Old Rochester Regional School District  
Athletic fields renovation project DSB#25-05

Addenda One (1)

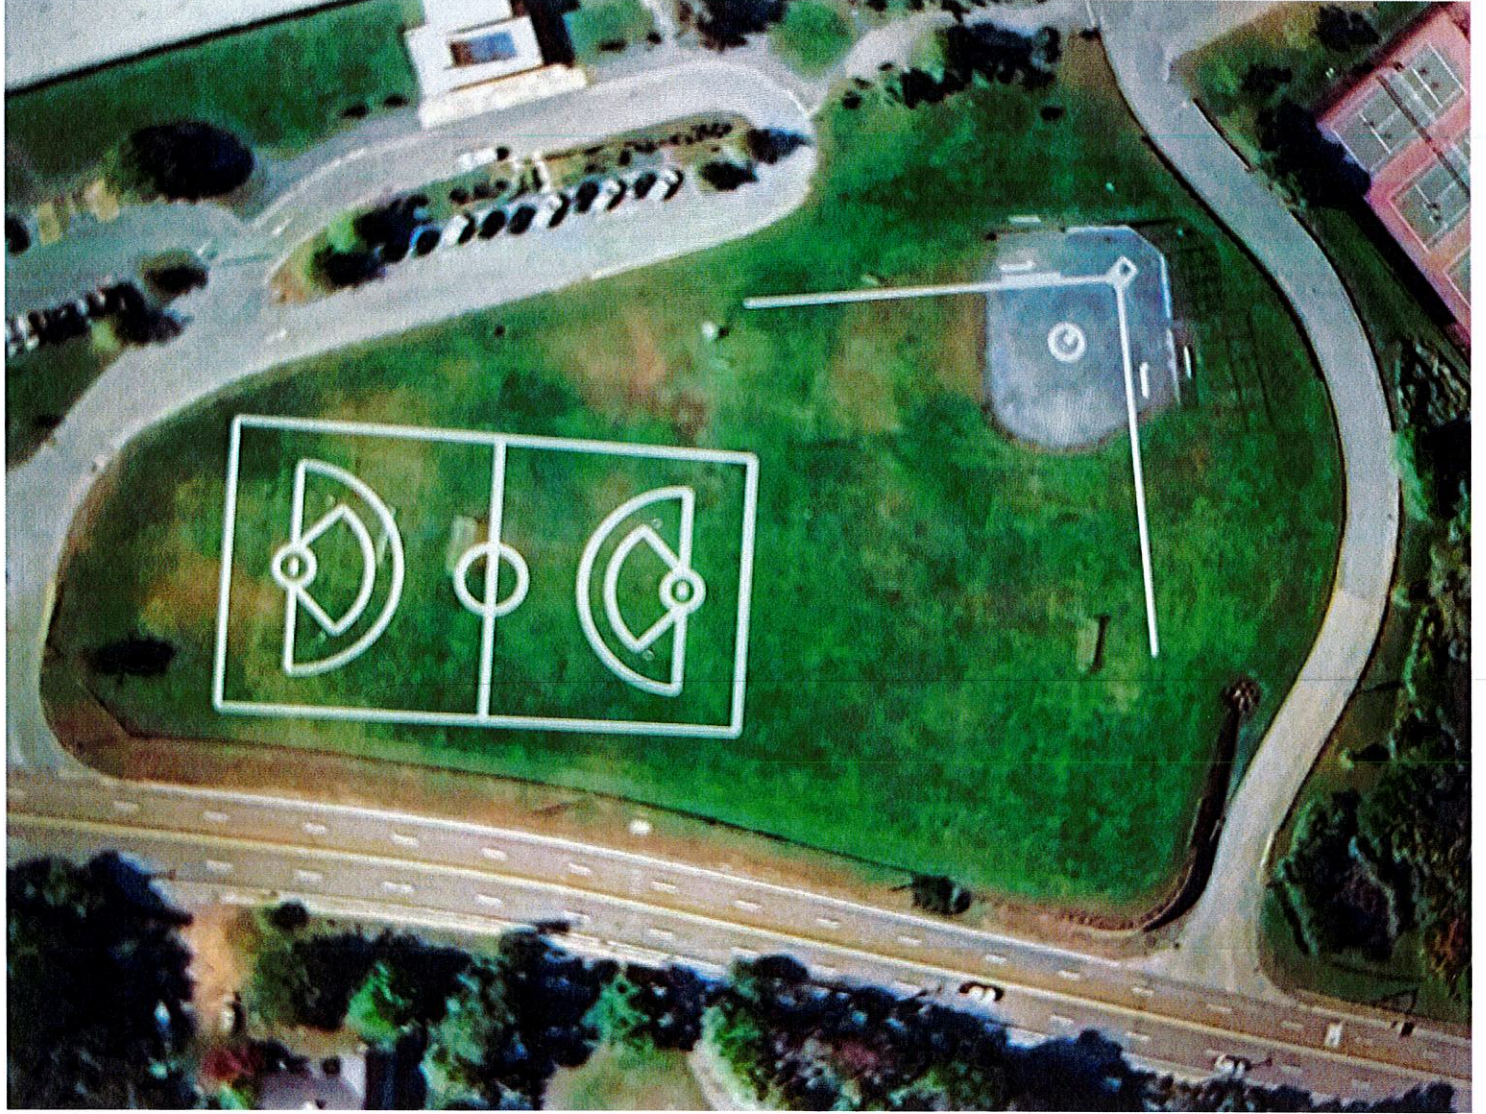
Question #2: Can you provide an extents of survey map that all bidders can use to get pricing. Survey costs can vary and if we all have the same general area it will help get an apples-to-apples comparison.

Request #1: Please provide a plan showing the limits of survey that you would like to have surveyed.

Answer: See attached maps

Response: Plan attached.
